Application for a Non-Material Amendment Following a Grant of Planning Permission

Proposed extension to ground, first and second floors to create new lift and lobby with disposal hold. Internal alterations to second floor to provide a new ward and ancillary accommodation. New external plant compound at ground floor adjacent to the building with roof mounted plant at roof level.

20/00595/FUL

Slight enlargement of proposed lift shaft. External ground floor facing material change.

Ground Floor plan 1:100

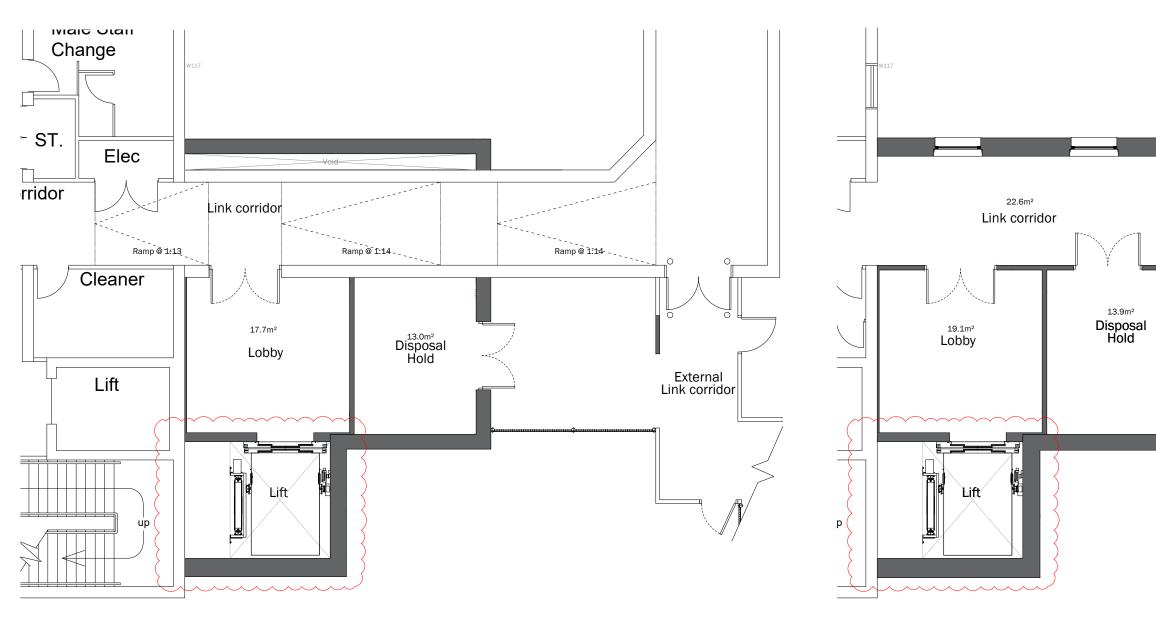
P4 19.11.21 Sheet and drawing number updated to exi format. Lift core size adjusted.

HC SH P3 22.04.21 External link corridor door relocated to suit new layout. HC SH P2 21.08.20 GF Disposal hold layout updated. HC LV P1 11.06.20 First Issue. HC LV rev: date: comment(s): name: check:

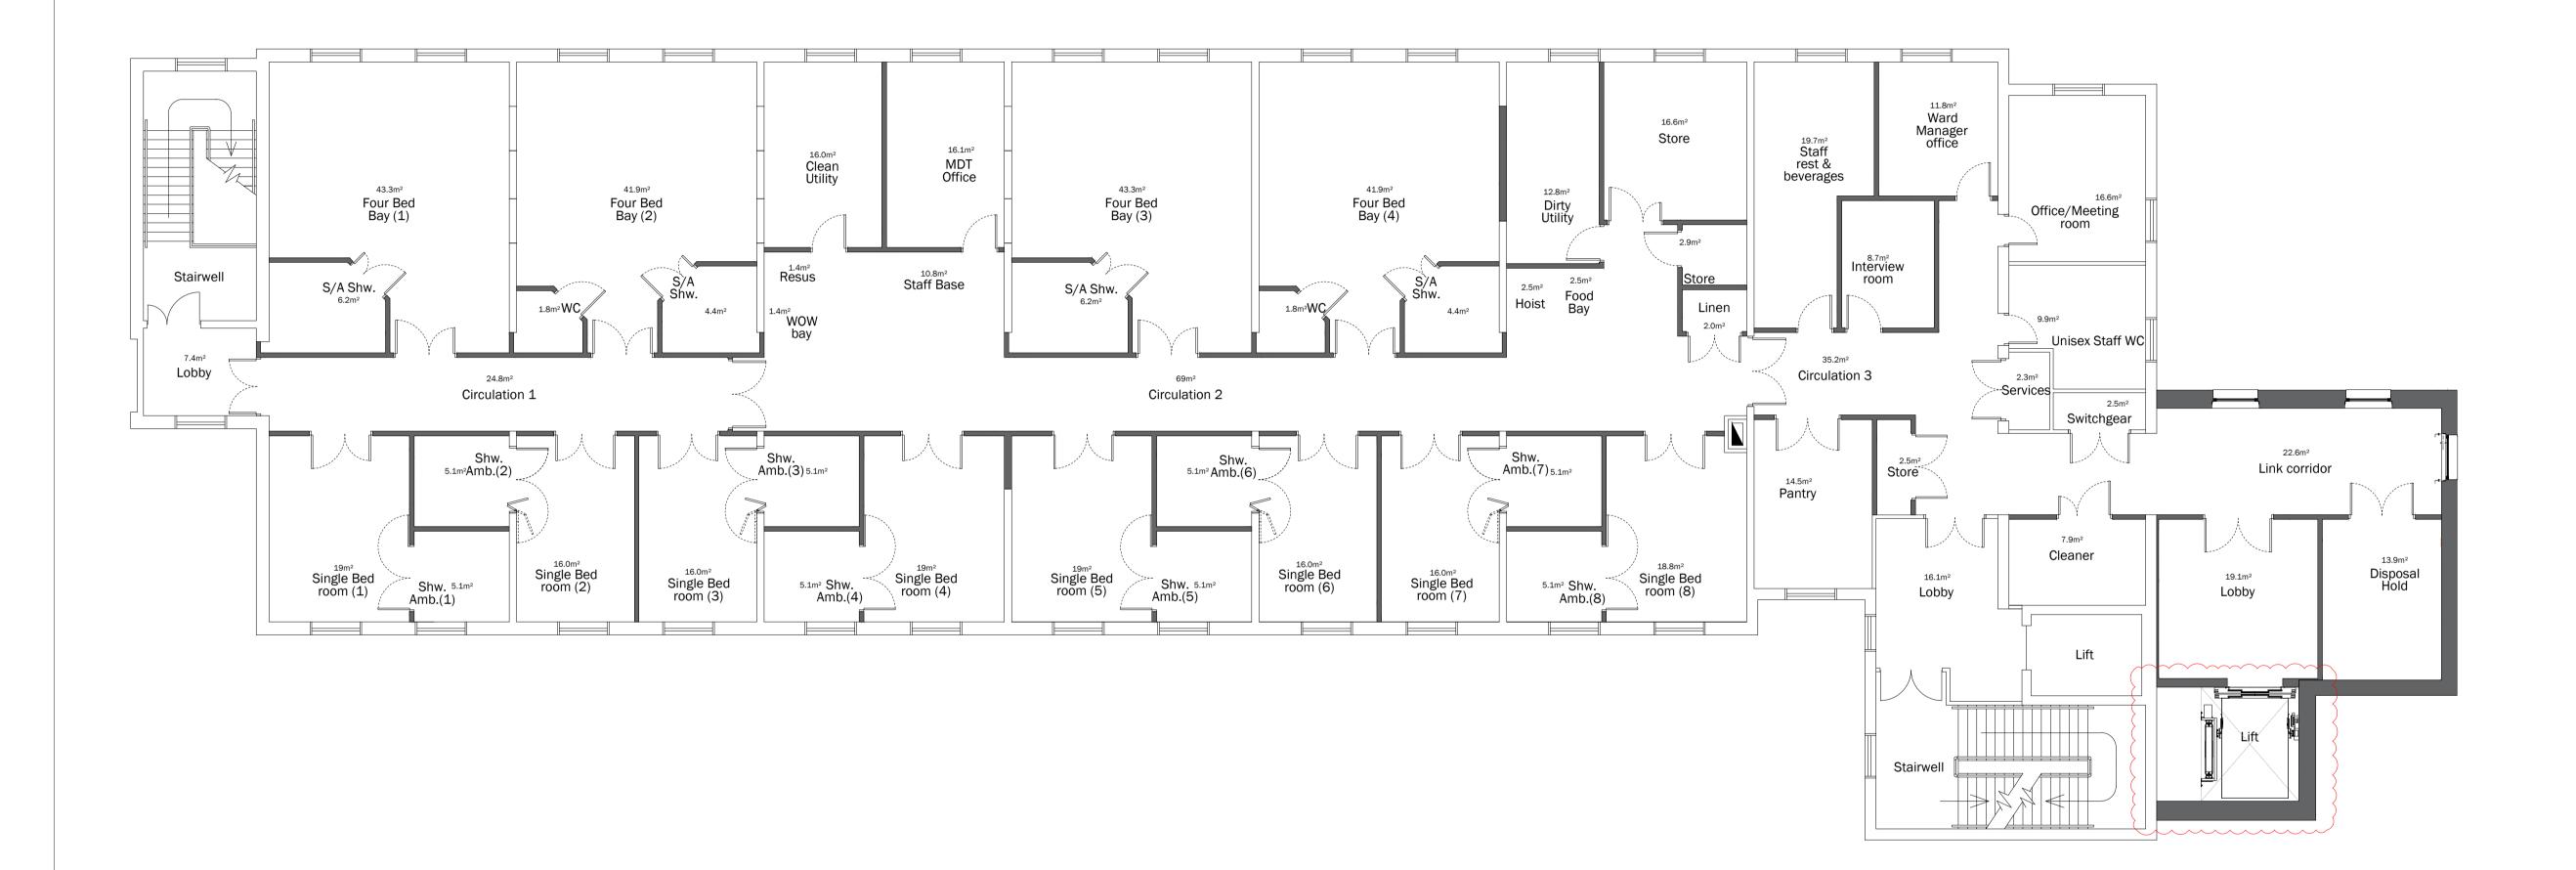
P2	19.11.21	Sheet and dr Lift core size c	awing number upc adjusted.	dated to	exi form HC	nat. LV			
P1	11.06.20	First Issue.			HC	LV			
rev:	date:	comment(s):			name:	check:			
	e		Understar Own. <mark>Deliver</mark> .	nd					
					exi ref:	H4072			
clie	ent: (Gloucesters	hire Hospital N	ihs ft					
job	: s	SD - Glouce	estershire Roy	al Hos	pital				
title	e: F	Proposed Se	econd Floor Pl	an					
dra	wn:	HC	date:	19.11	.2021				
che	ecked:	LV	scale (A1):	1:100)				
suit	ability:	-	purpose:	Planr	ning				
drg no: 4072-EXI-314-P2									
The	The Walker Suite//Butts Park Arena//Coventry//CV1 3GE

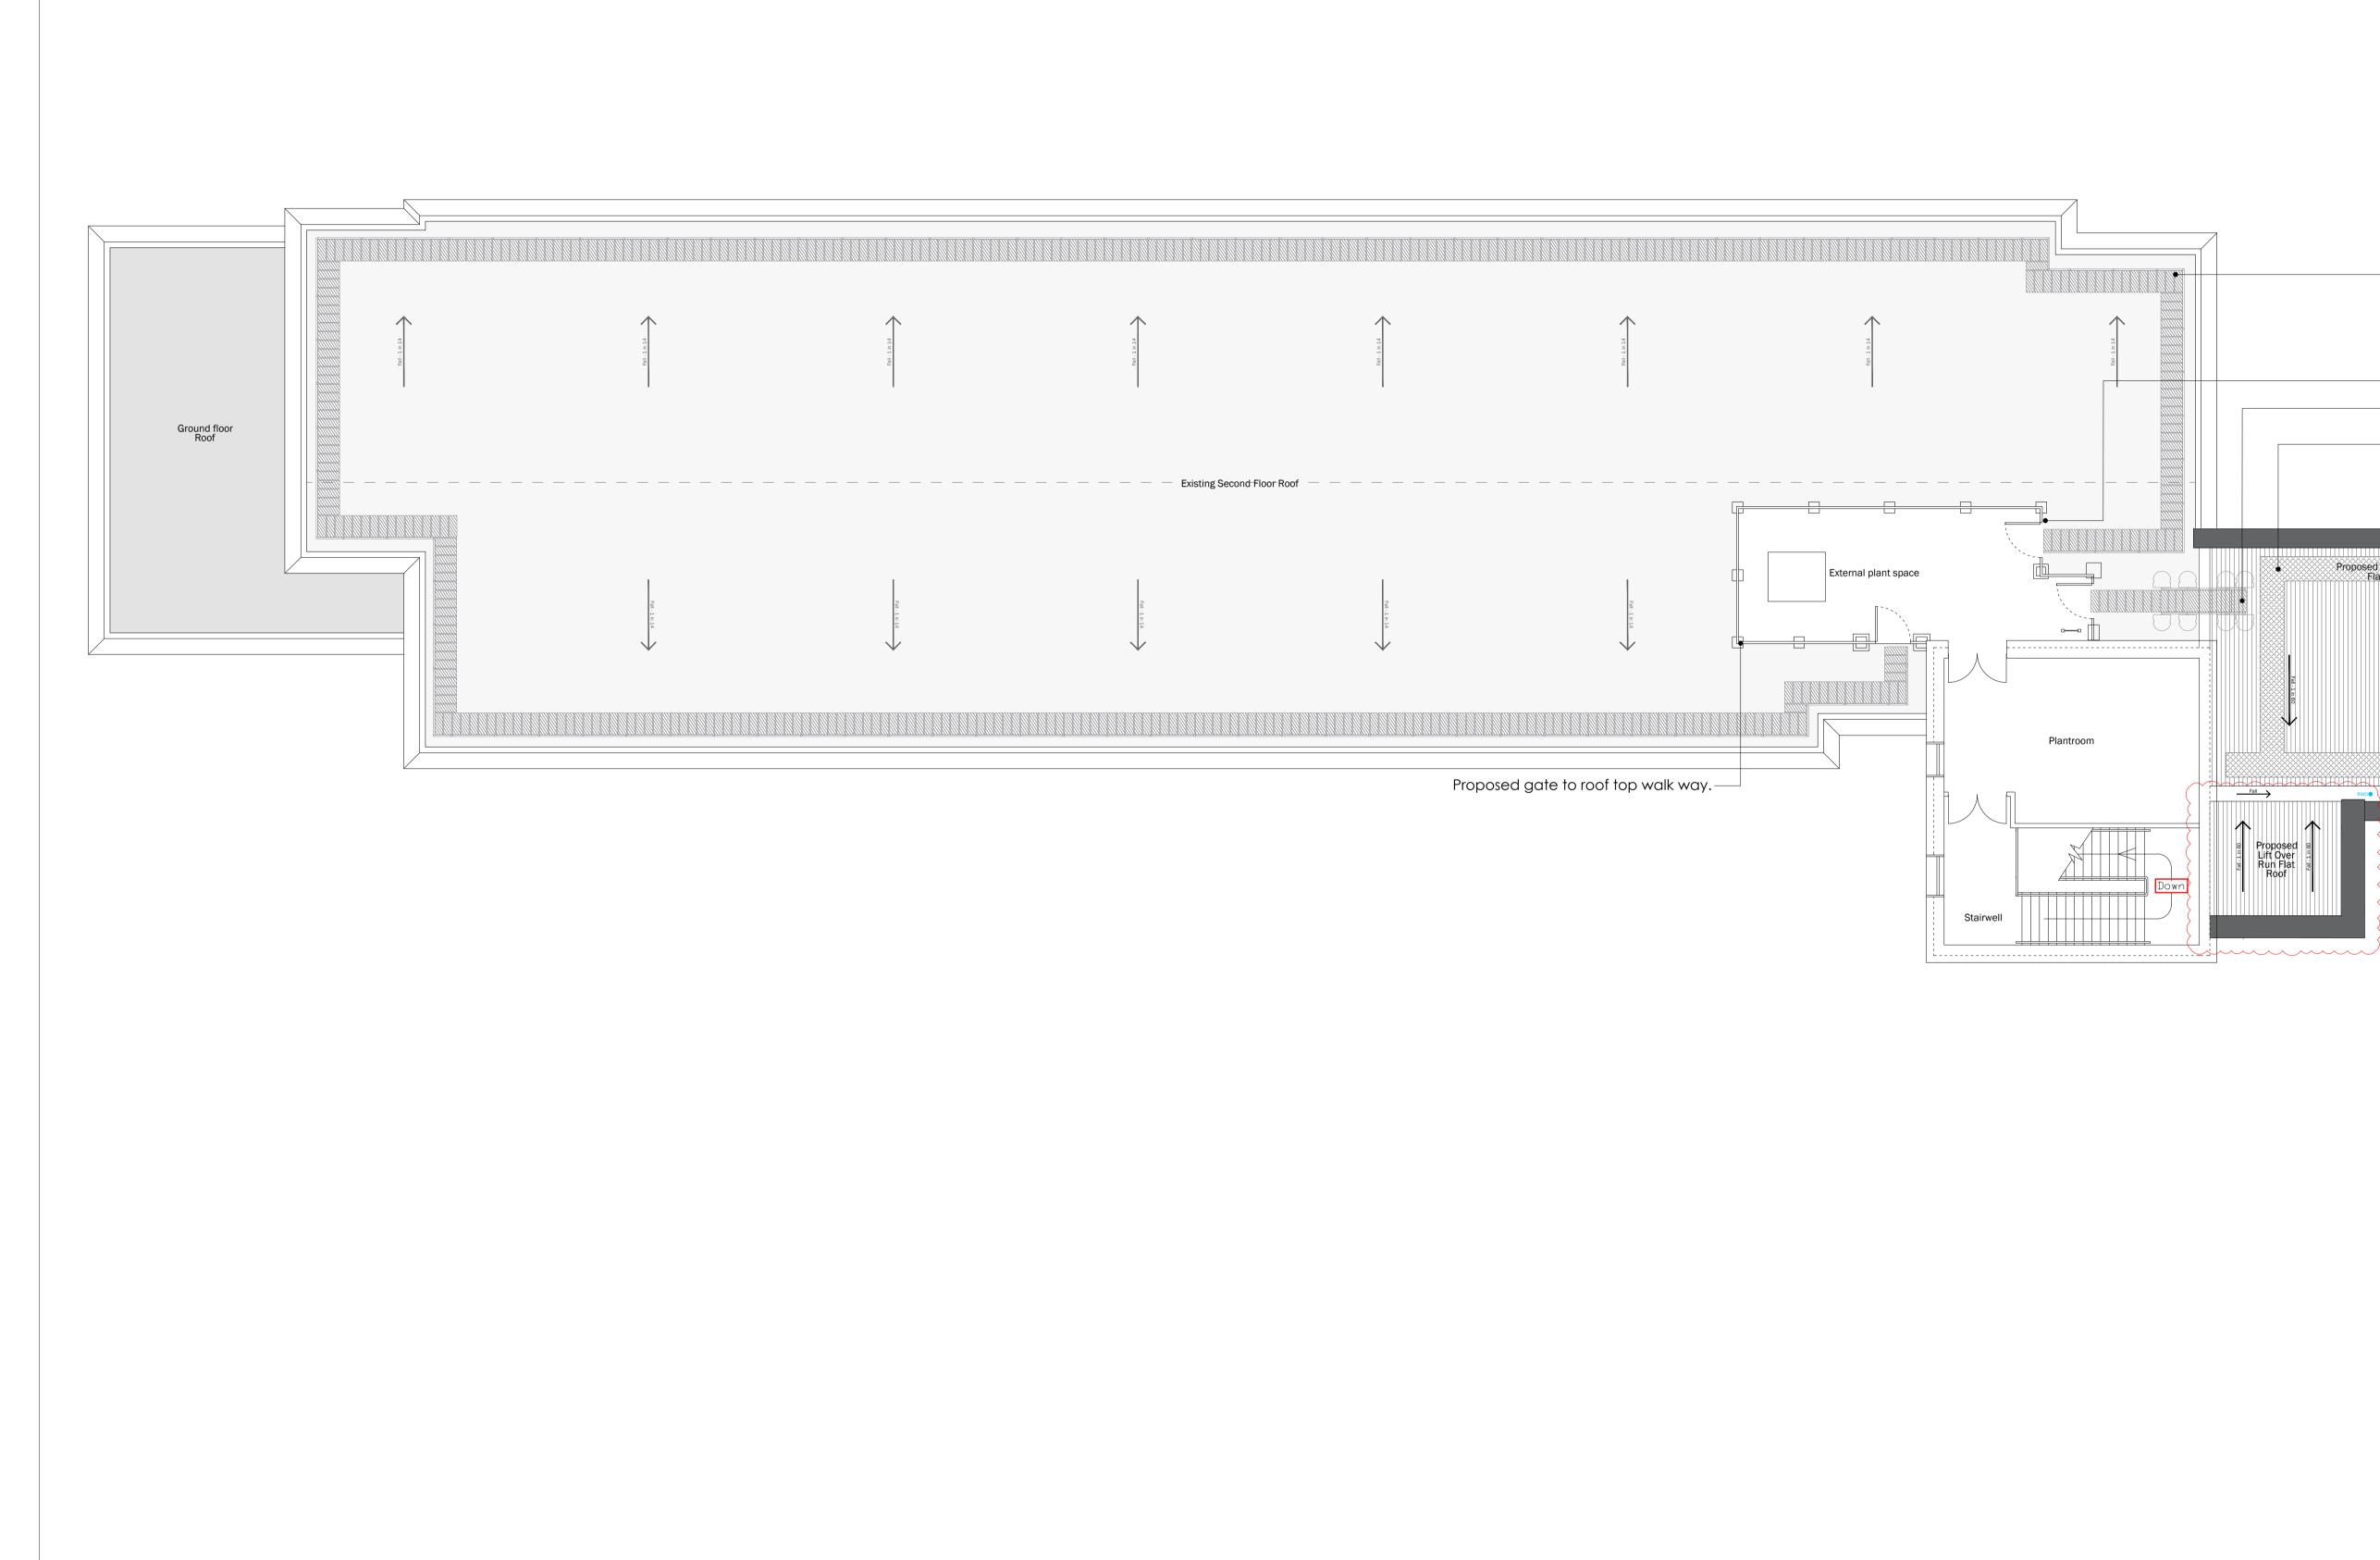
P3	19.11.21	Sheet and drawing number updated to	exi form	nat.					
		Lift overrun size adjusted.	HC	LV					
P2	22.04.21	Ducting omitted. Roof top walk way & hope over steps adjusted to suite layout changes.	HC	SH					
P1	11.06.20	First Issue.	HC	LV					
rev:	date:	comment(s):	name:	check:					
	e	Understand Own. Deliver.	exi ref:	H4072					
clie jot	ent: Gloucestershire Hospital NHS FT b: SSD - Gloucestershire Royal Hospital								
title	e: I	Proposed Roof Plan							
dro	awn:	HC date: 19.11	.2021						
ch	ecked:	LV scale (A1): 1:100							
sui	tability:	- purpose: Plann	ing						
drg no: 4072-EXI-315-P3									
The Walker Suite//Butts Park Arena//Coventry//CV1 3GE
